PLANNING RESPONSES
SUNLIGHT HOUSE
OCTOBER 2024

GROUND FLOOR CAFE GLAZING

CDN/24/0714 & CDN/24/0713

This document forms a response to CDN/24/0714 (Condition 7) and CDN/24/0713 (Condition 11). Some areas of this glazing had to be revisited and redesigned in line with the Fire requirements and to support the latest reception layout and cafe testfits.

DRAFT ELEVATION DRAWING

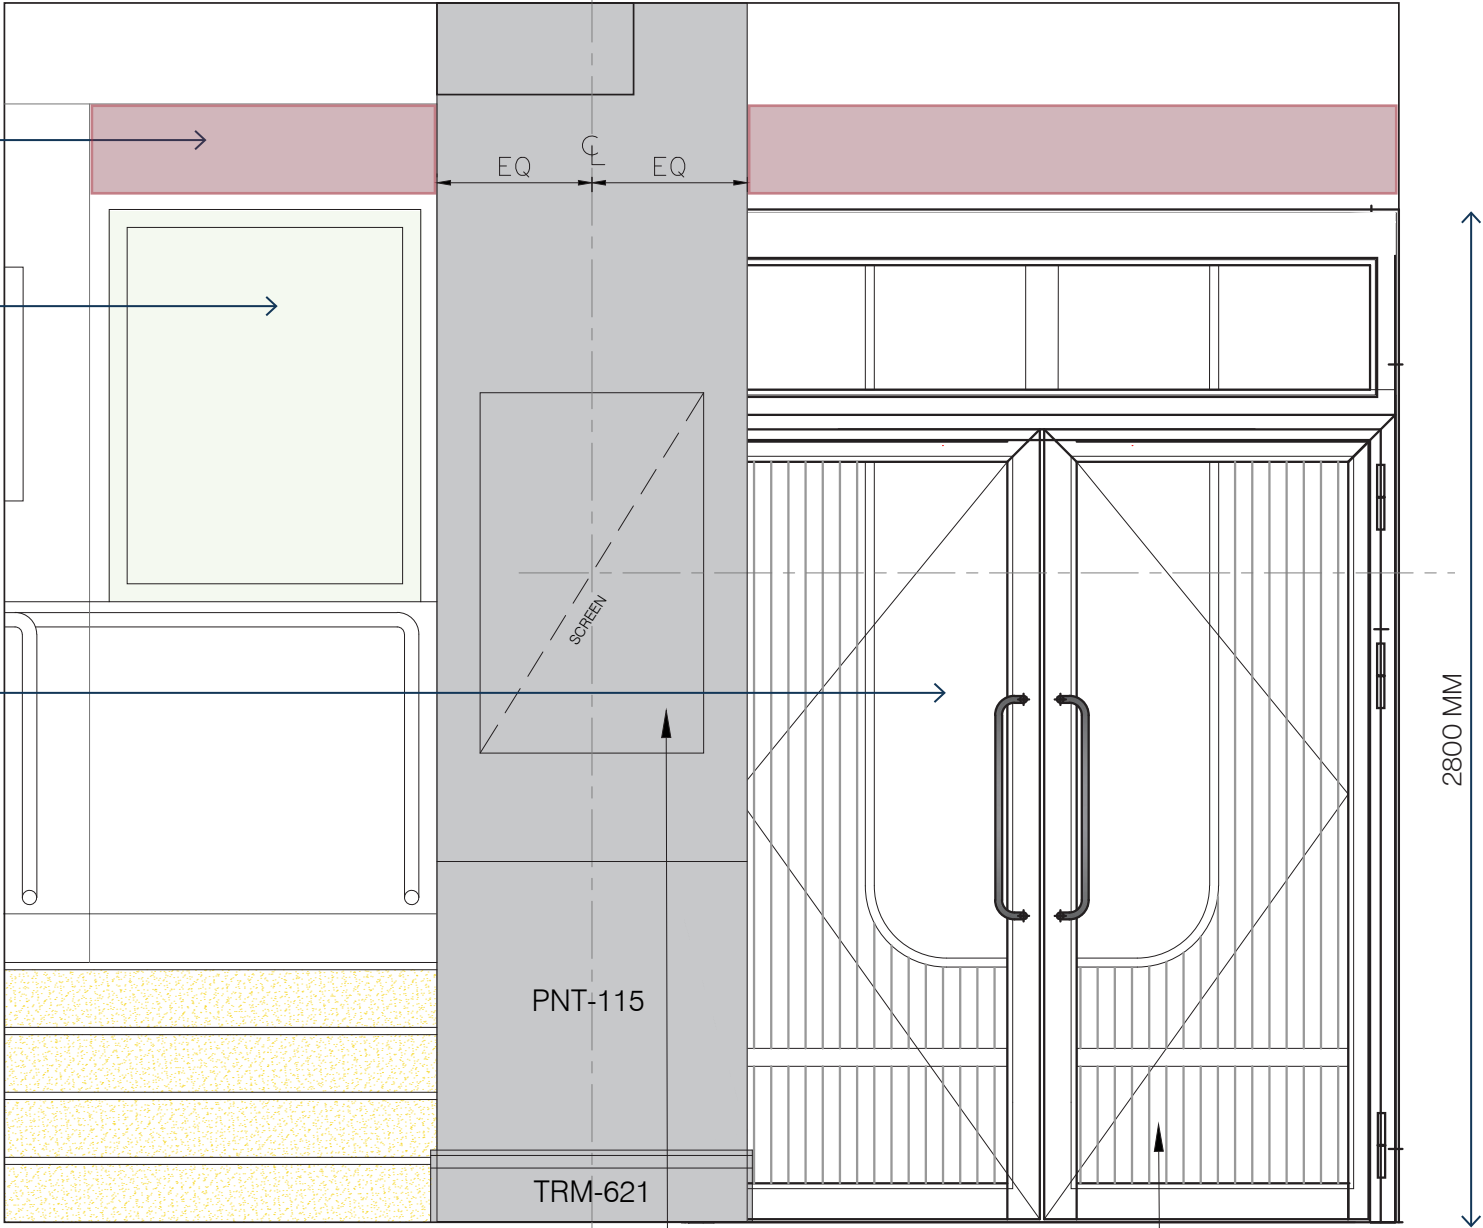
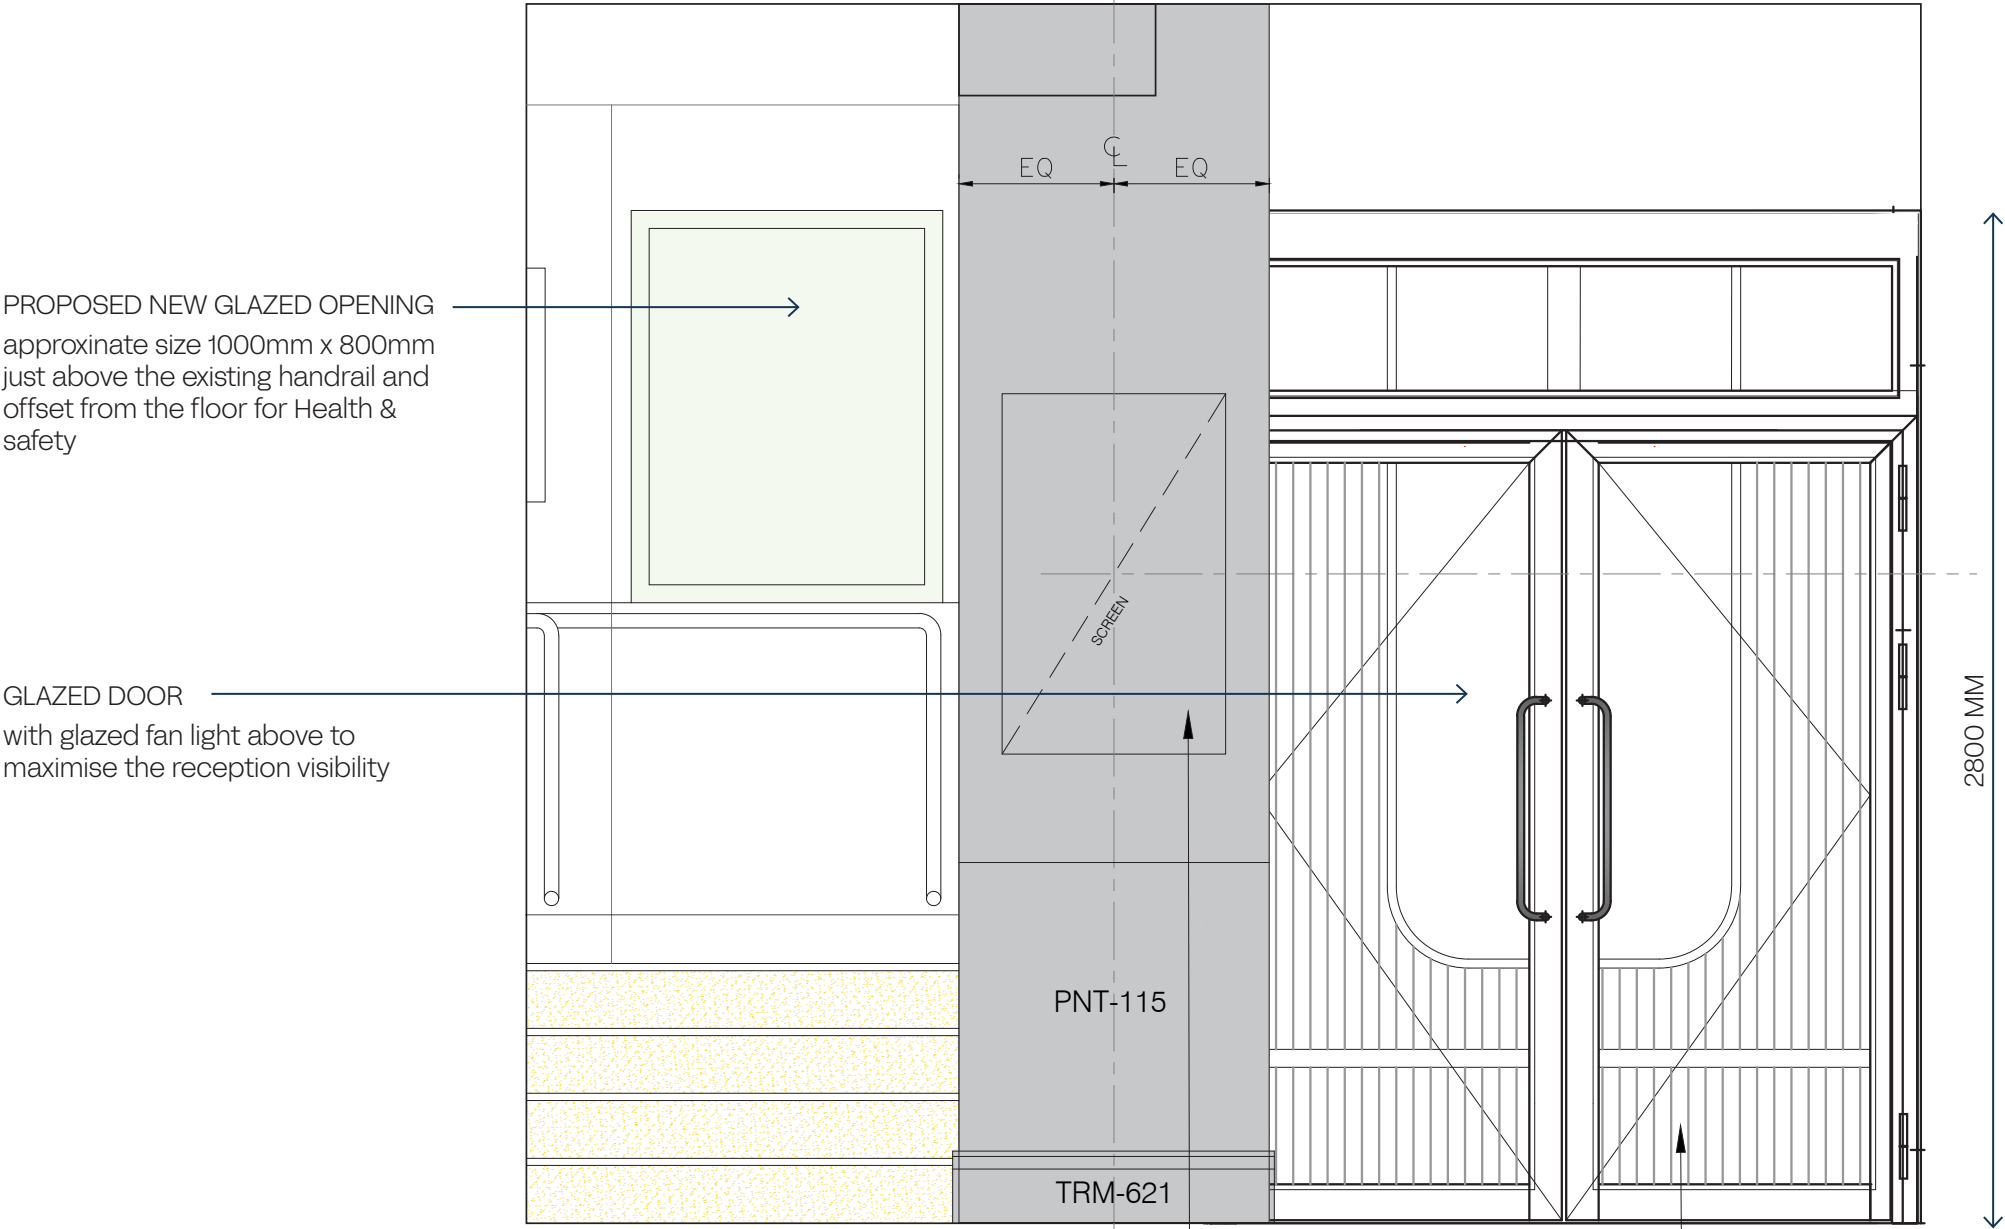
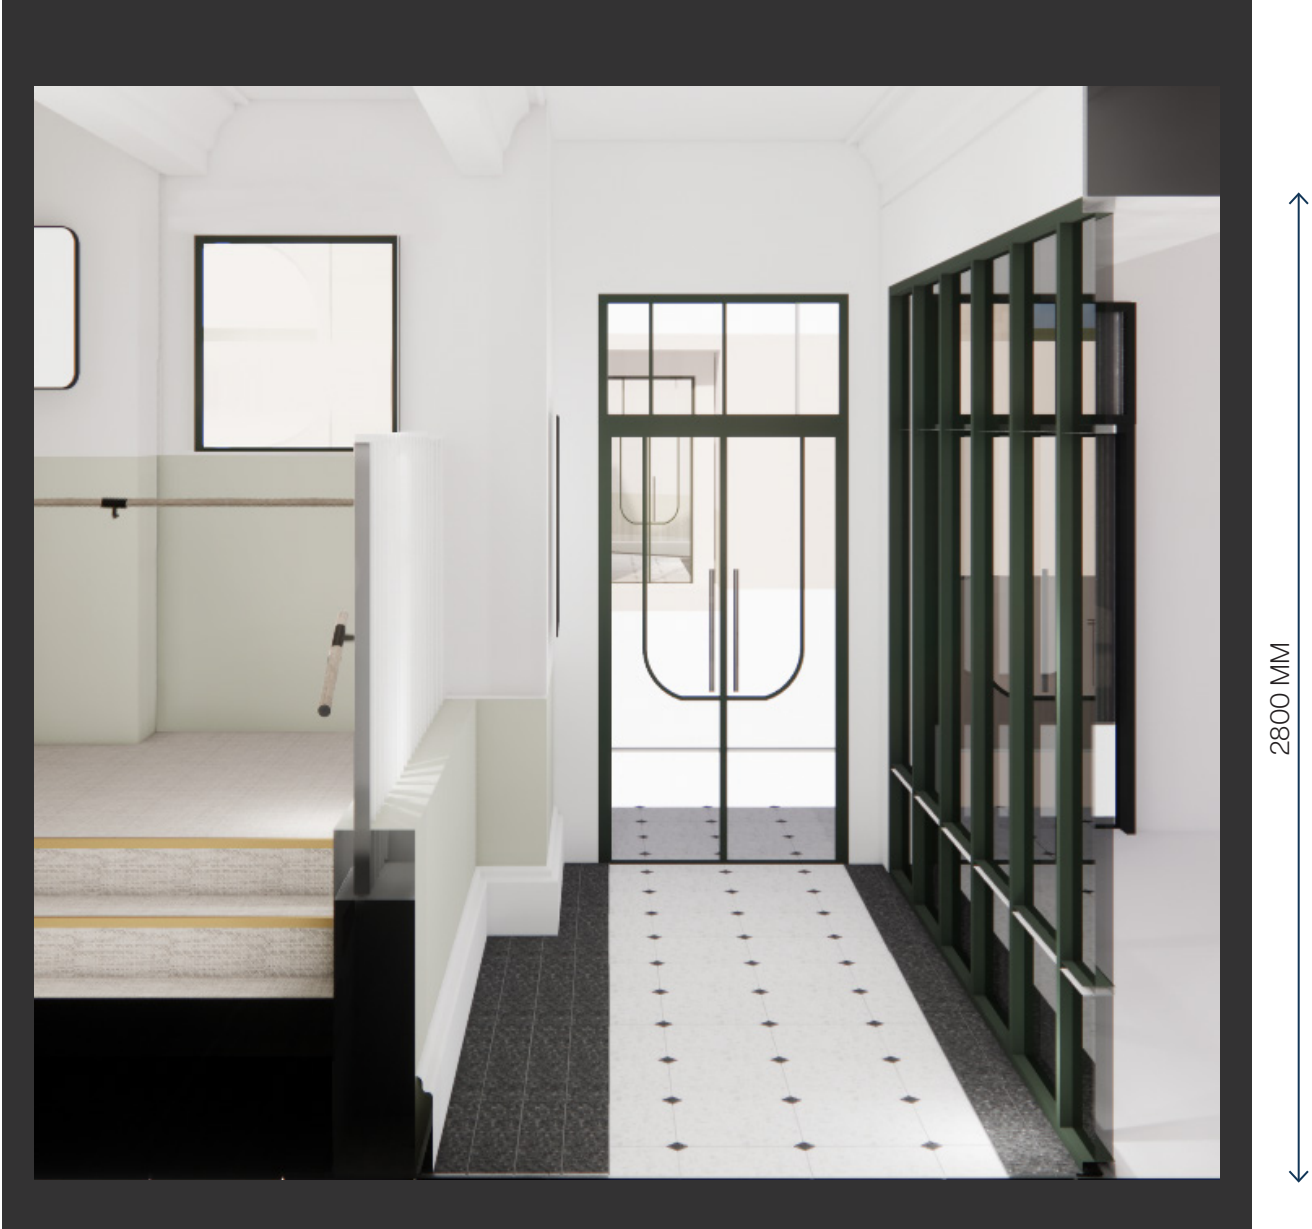
Beam heighs vary, with the lowest beam being at 3100mm in this area.
All glazing is to uniform height of 2800mm leaving 300mm for the service zone under the historic coffer

PROPOSED NEW GLAZED OPENING
approximate size 1000mm x 800mm
just above the existing handrail and
offset from the floor for Health & safety

GLAZED DOOR
with glazed fan light above to
maximise the reception visibility

BOXING OUT FOR SERVICES
TO BE REBUILD

DRAFT ELEVATION DRAWING

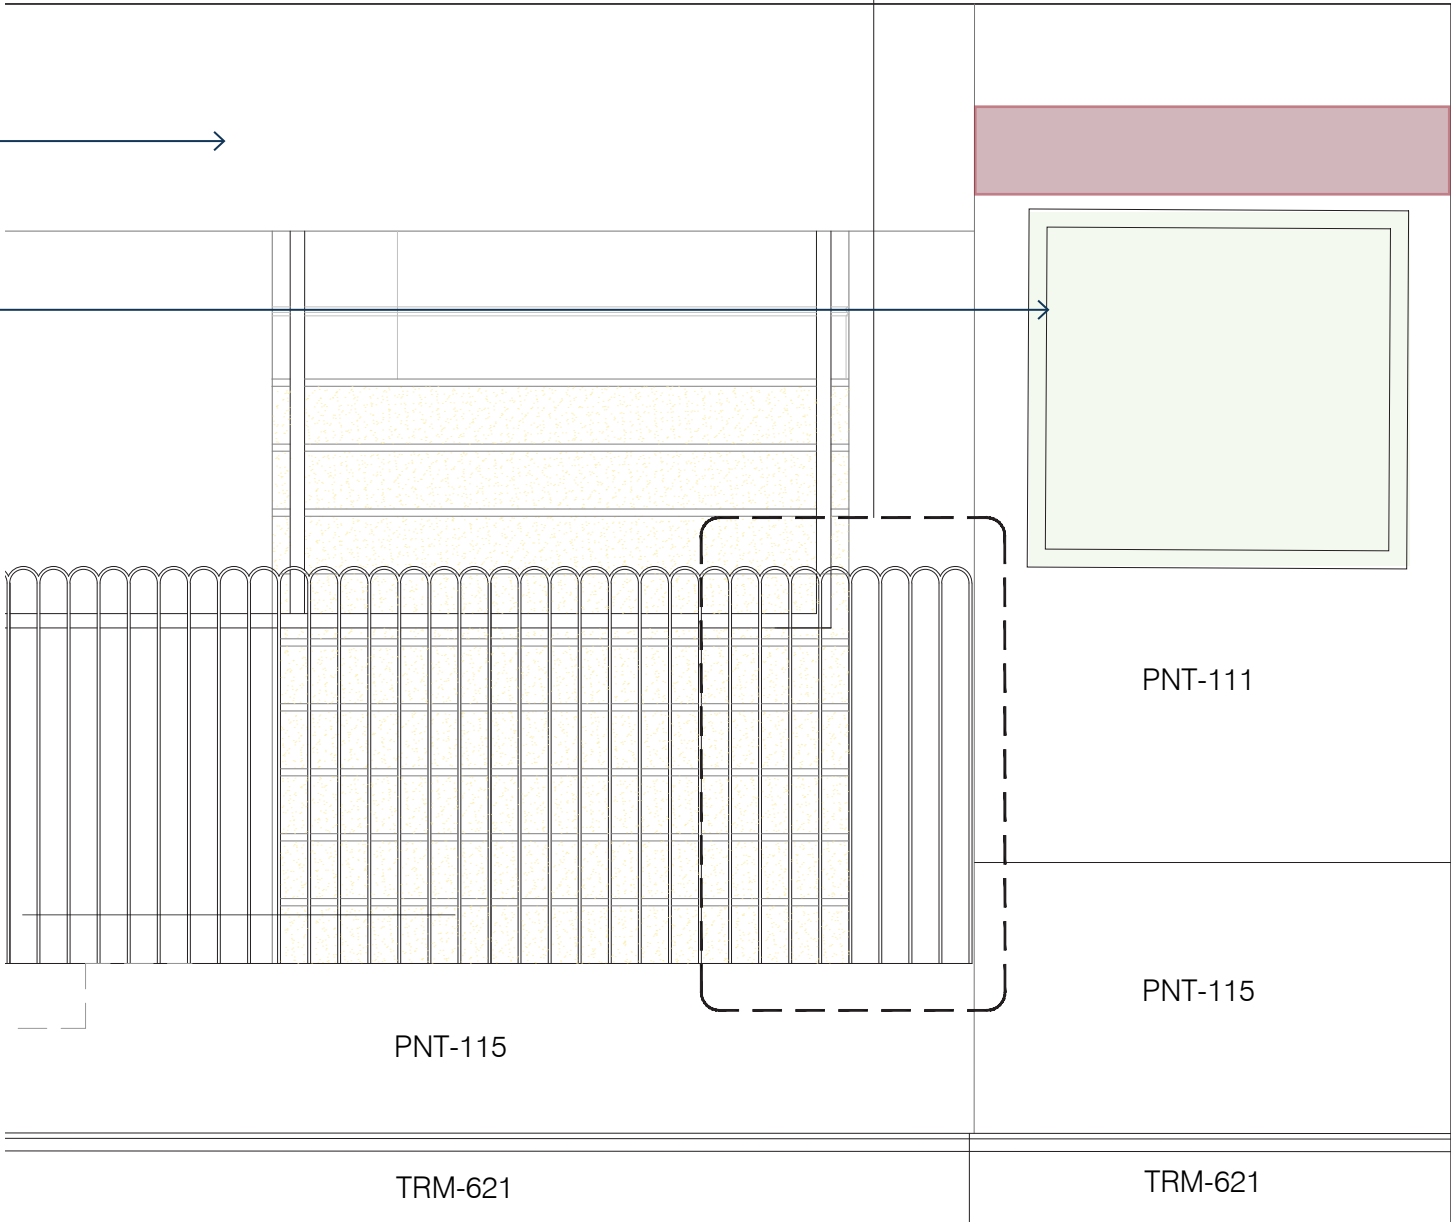
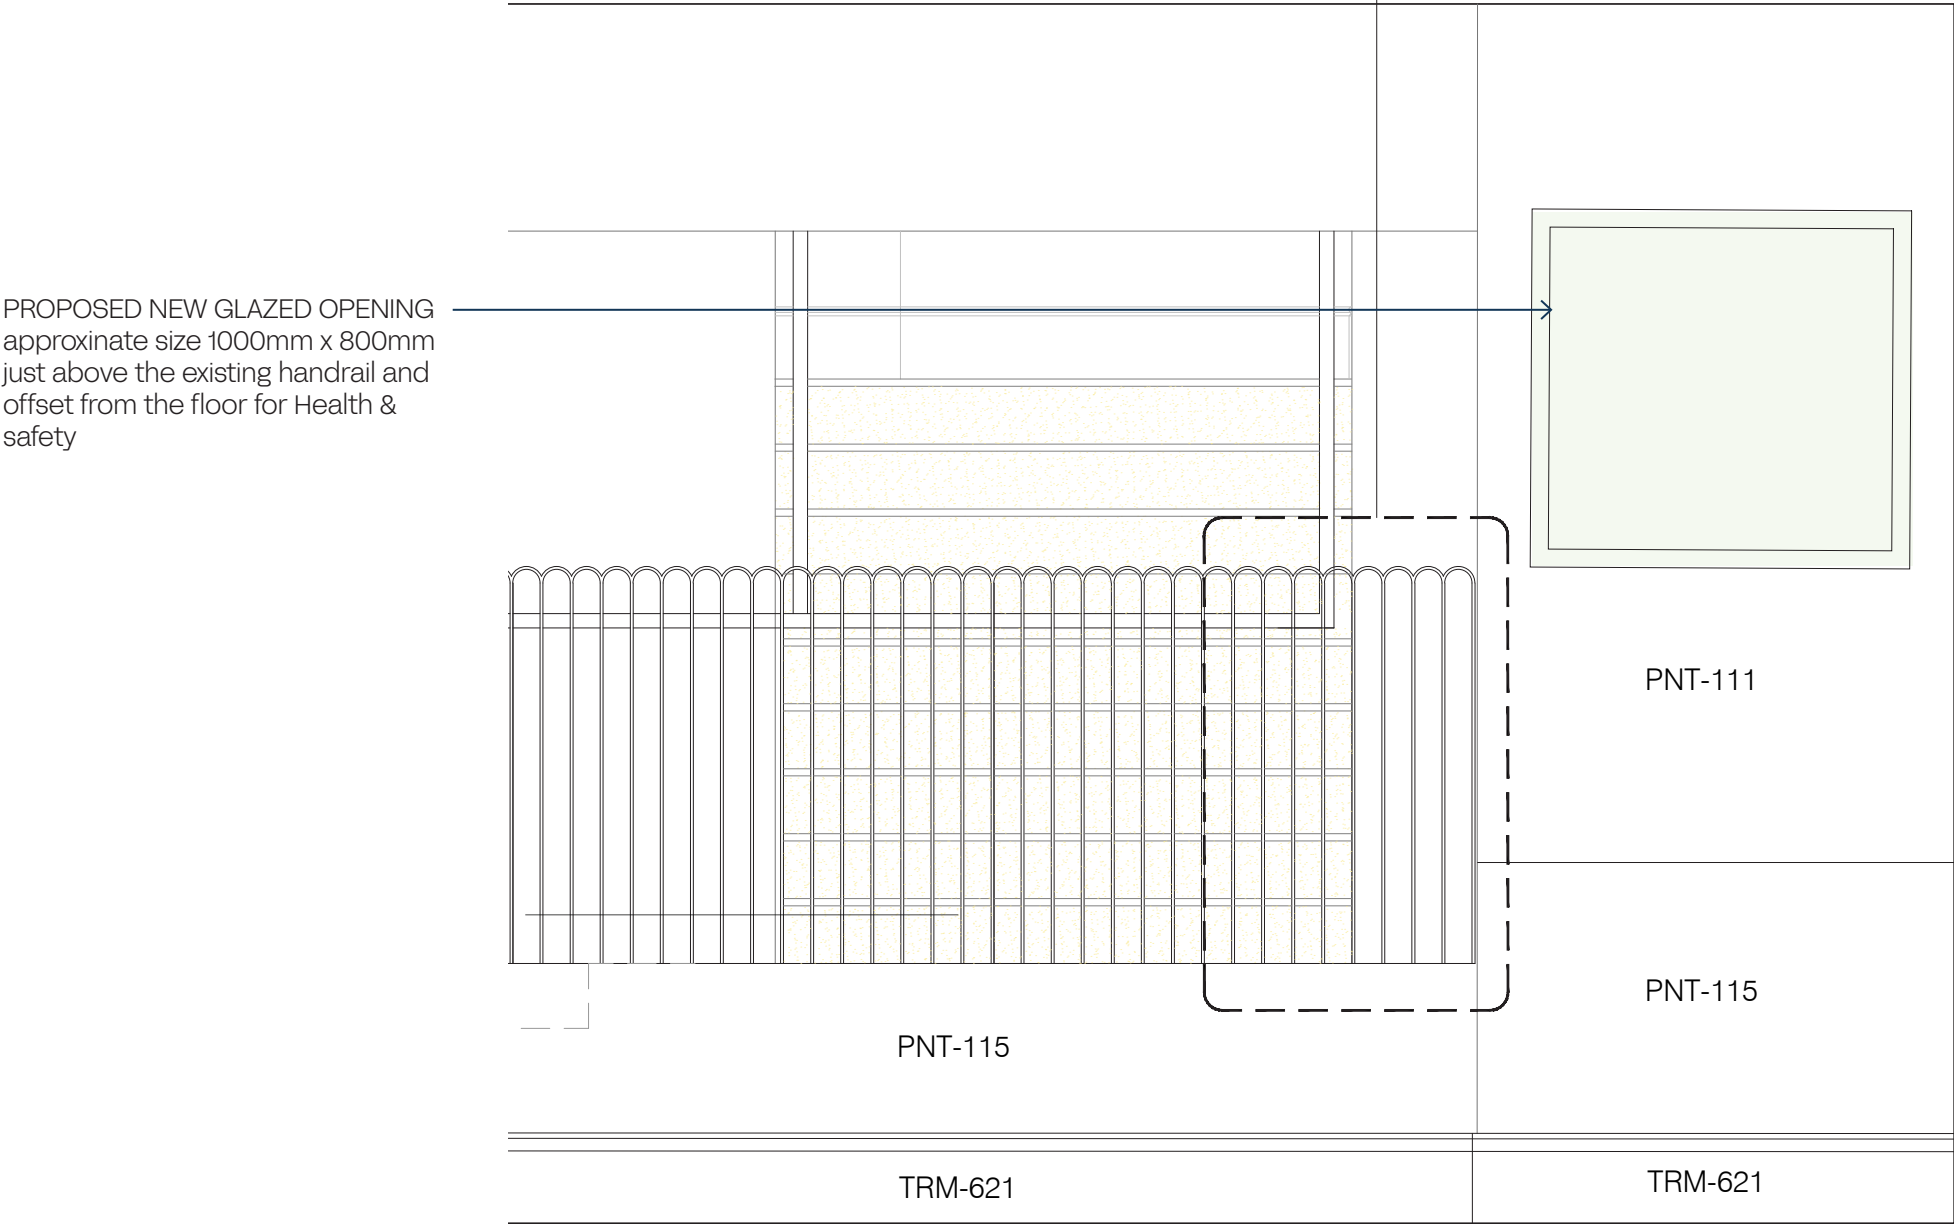
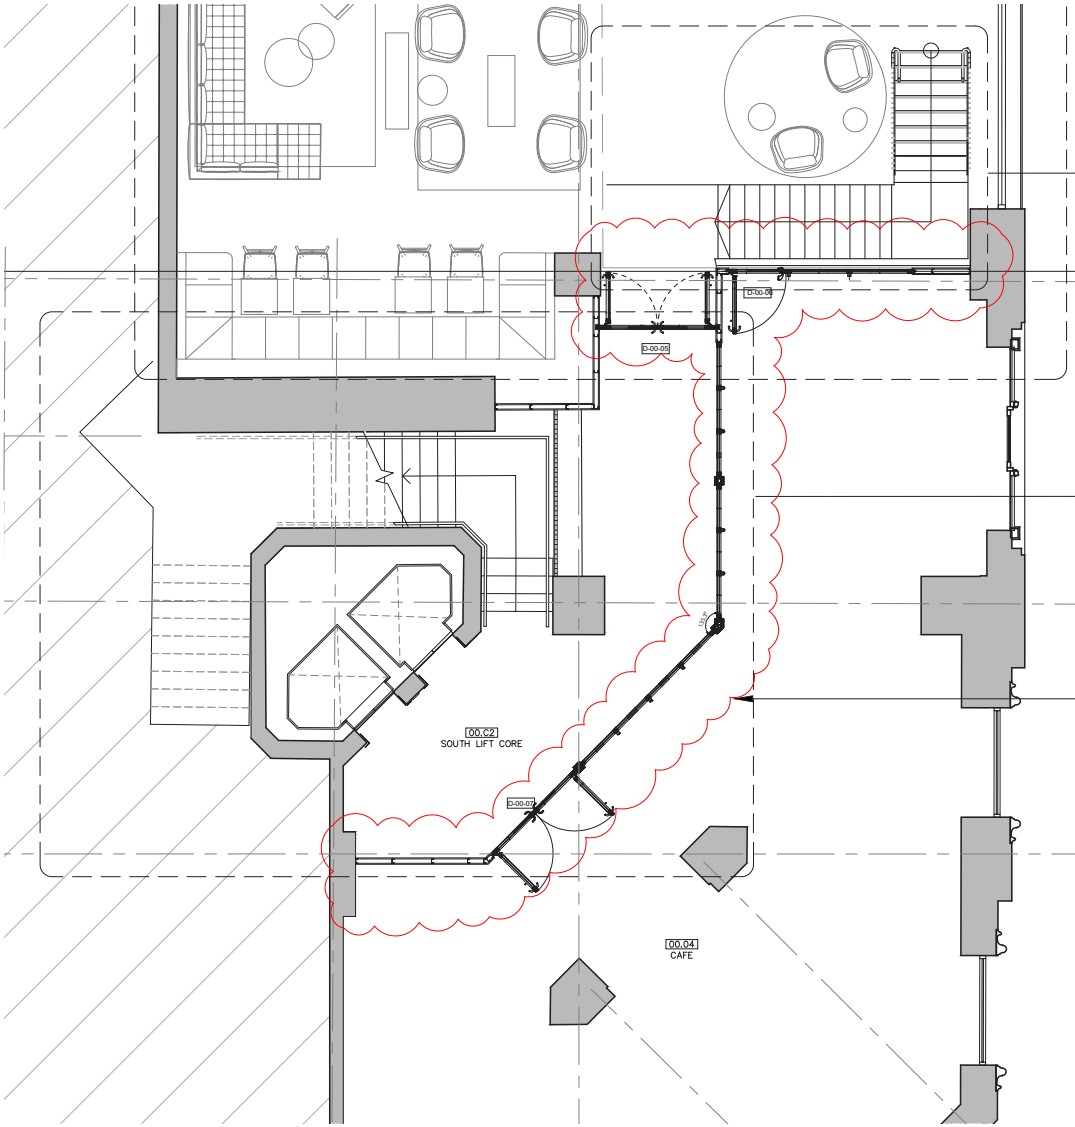
Beam heighs vary, with the lowest beam being at 3100mm in this area.
All glazing is to uniform height of 2800mm leaving 300mm for the service zone under the historic coffer

PROPOSED NEW GLAZED OPENING
approximate size 1000mm x 800mm
just above the existing handrail and
offset from the floor for Health &
safety
